# JAGUAR LAND ROVER JSP17-65

Public Hearing at the request of Erhard Motor Sales, Inc for Planning Commission’s recommendation to City Council for consideration of a Special Development Option Concept Plan in the GE, Gateway East zoning district. The subject property is comprised of two parcels totaling 9.48 acres. It is located on the southwest corner of Grand River Avenue and Meadowbrook Road (Section 23). The applicant is proposing to build a 58,663 square feet car sales facility for Jaguar Land Rover. The concept plan proposes 138 parking spaces and 287 parking spaces for storing cars for sale.

## Planning Review JAGUAR LAND ROVER

SDO Concept Plan

ORIGINAL ISSUE DATE: AUGUST 6, 2018  
 PEA JOB NO. 2017-176  
 SCALE:  
 DRAWING NUMBER:  
**SP-2.0**

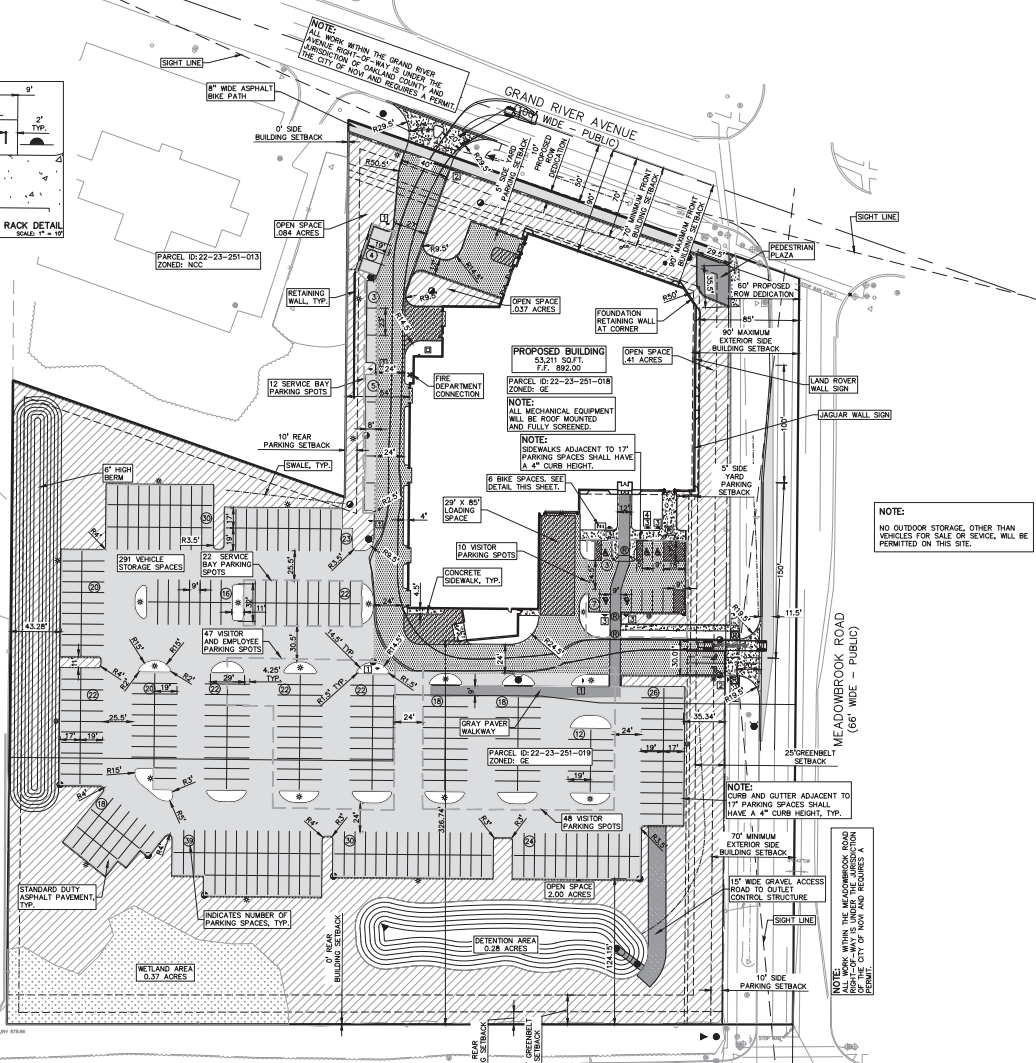
- a. For not meeting the minimum requirements for usable open space (25% of gross area of the site required); **The applicant is asked to meet the minimum ordinance standards, and provide the updated calculations with an exhibit that included spaces designed as useable space. Additional revisions may be required for the proposed pedestrian plaza at the corner of Meadowbrook Road and Grand River Avenue.**

- f. The applicant is required to provide two (2) bicycle parking spaces for the service center section of the development and six (6) have been provided. A bicycle parking layout is shown on sheet SP-2.0 but a dimension for the width of the sidewalk should also be included.

Updated calculations demonstrating compliance with the Open Space requirements will be added to sheet SP-2.0.

Bike racks will be relocated to limit the number of racks at any one entrance on sheet SP-2.0.

Additional calculations will be added to SP-2.0 to demonstrate conformance with open space requirements.

Corner clearance zones will be added to SP-2.0 to the next resubmittal.

ORIGINAL ISSUE DATE: AUGUST 6, 2018  
 PEA JOB NO. 2017-176  
 SCALE: 1" = 50'  
 DRAWING NUMBER: L-1.0

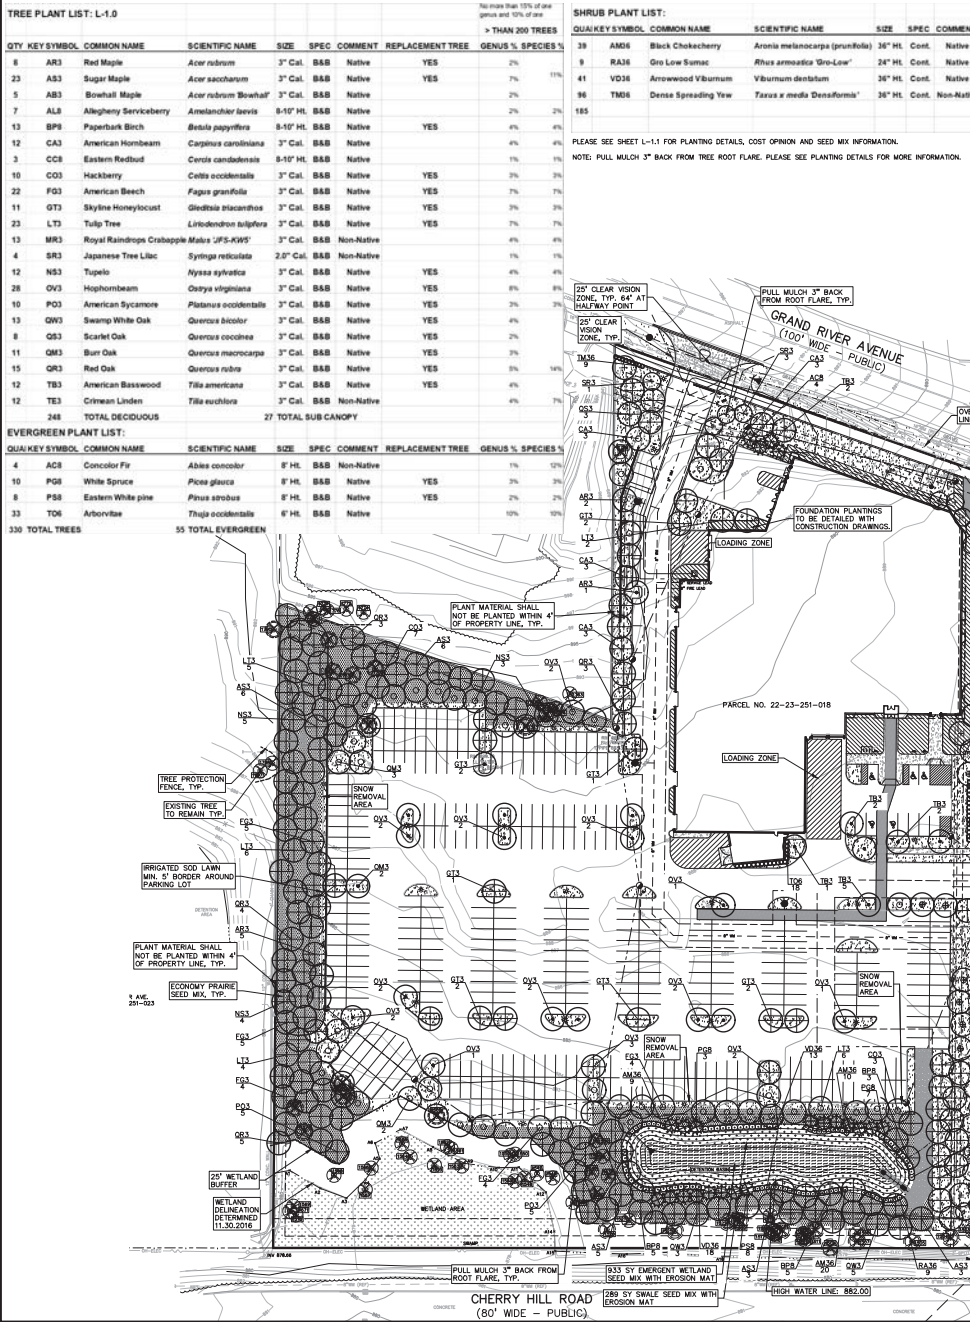
- g. Landscape deviation from Section. 5.5.3.E.i.c for lack of street trees along Grand River Road frontage due to lack of space (8 trees required);
  - h. Landscape deviation from Section. 5.5.3.E.i.c for lack of street trees along Cherry Hill Road frontage due to lack of space (8 trees required);

- j. Landscape deviation from Section. 5.5.3.E.i.c for lack of street trees along Grand River Road frontage due to lack of space (8 trees)
- k. Landscape deviation from Section. 5.5.3.E.i.c for lack of street trees along Cherry Hill Road frontage due to lack of space (11trees)
- l. Landscape deviation from Section 5.5.3.B.ii and iii for not providing greenbelt berm or plantings in area of wetland in order to preserve wetland
- m. Landscape deviation from Section 5.5.3.B.ii and iii for not providing greenbelt berm or plantings between Cherry Hill and the parking lot area not behind the wetland. **This is currently not supported by staff.**

drawing:  
**Proposed Elevations**

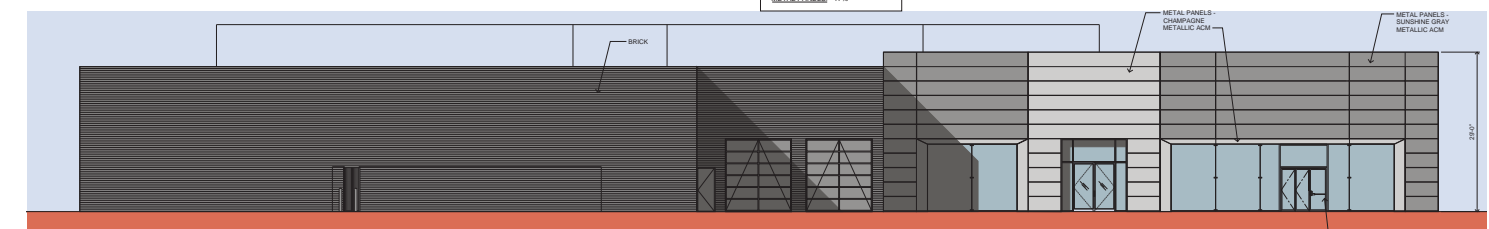
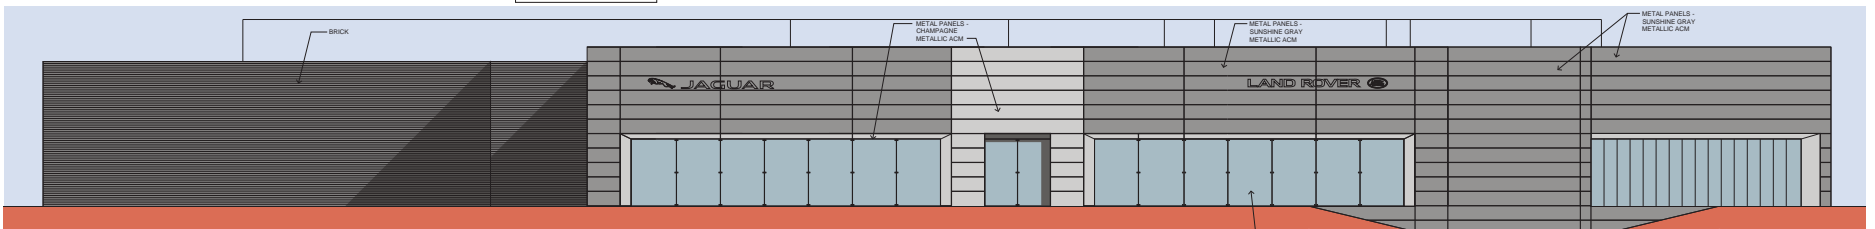
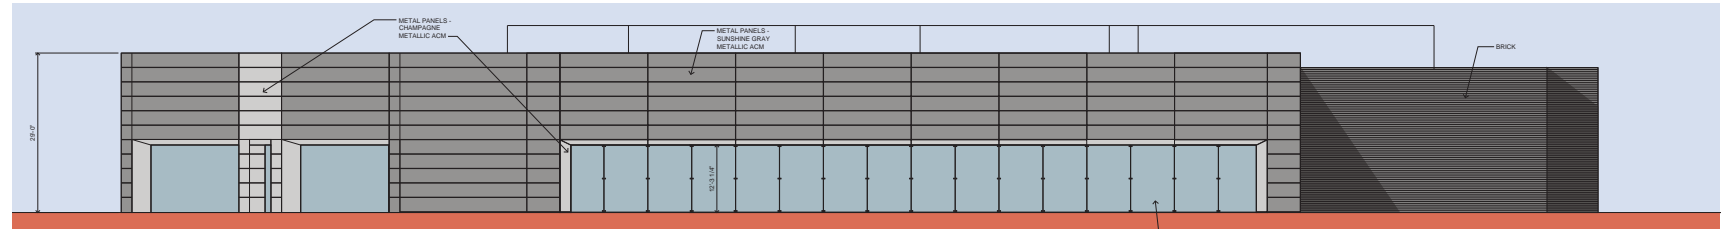
- i. Underage of brick (30% minimum required, 25% on north façade and 28% on east façade proposed);
    - ii. Overage of flat metal panels (50% maximum allowed, 58% on north façade and 56% on east façade proposed);

- iii. Overage of horizontal rib metal panels for roof top screening (0% allowed, 17% on north, 16% on east, 12% on south and 18% on west proposed);

Section 3.11.8 of the Ordinance states that buildings located at the corner of two streets within the Gateway East District "... shall contain two stories or incorporate architectural features that provide additional massing." The proposed building exhibits no additional massing near the intersection of Grand River and Meadowbrook Rd., and is generally inconsistent with this requirement.

**The applicant should consider revising the design to add architectural features, specifically to the north east corner of the building that will meet the intent of this Section.**

**Figure 1.** City of Novi Regulated Wetland & Woodland Map (approximate project boundary shown in red). Regulated Woodland areas are shown in green and Regulated Wetland areas are shown in blue.

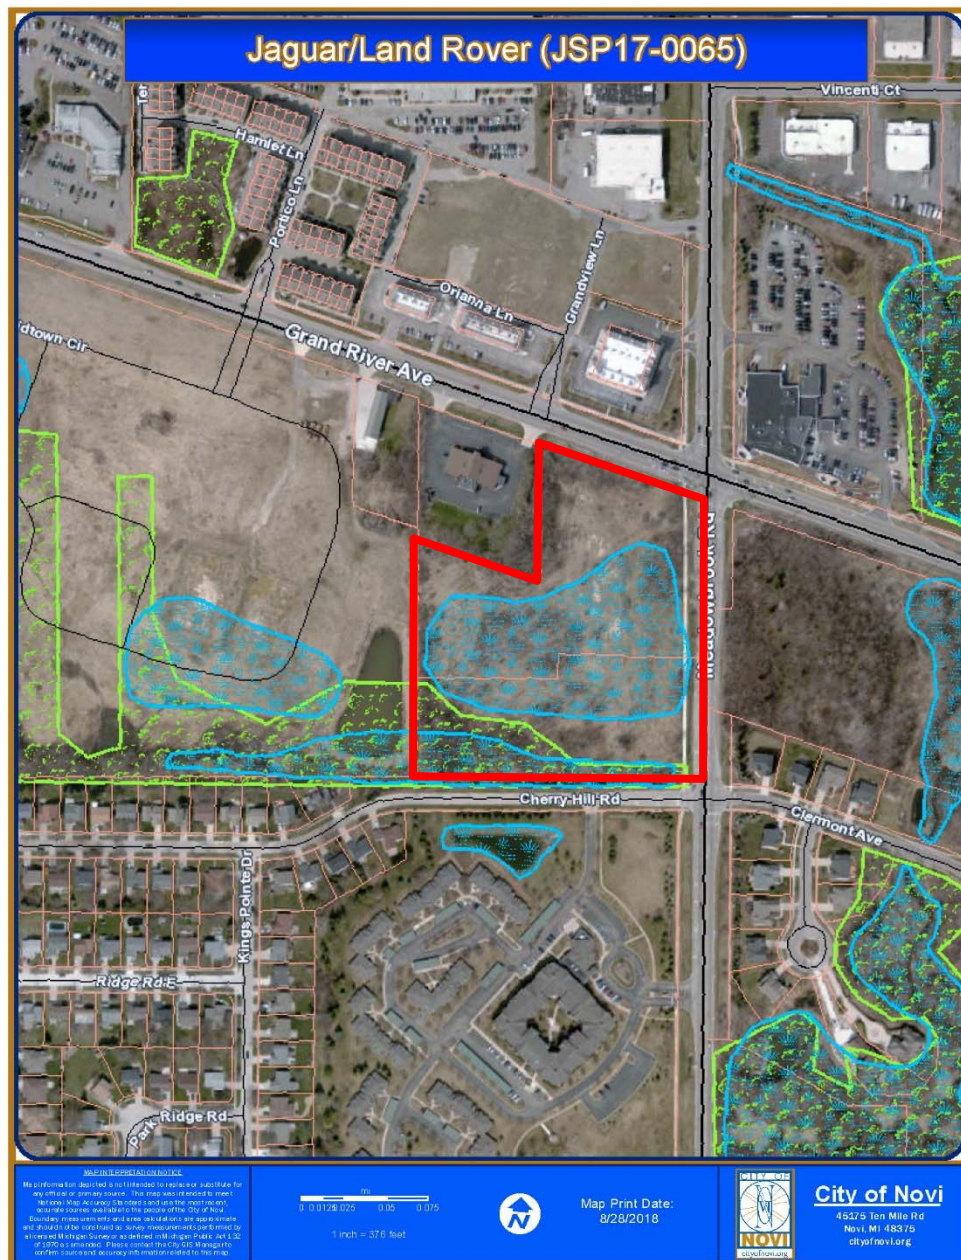
ECT has verified that the Wetland A boundaries appear to be accurately flagged in the field and depicted on the Wetland Location Map. It can be noted that the City of Novi's Regulated Wetland Map (Figure 1) is not accurate in indicating the location of wetland on the subject property. The Wetland Location Map provided by Niswander Environmental (Figure 2) does appear to accurately portray the existing wetland location.
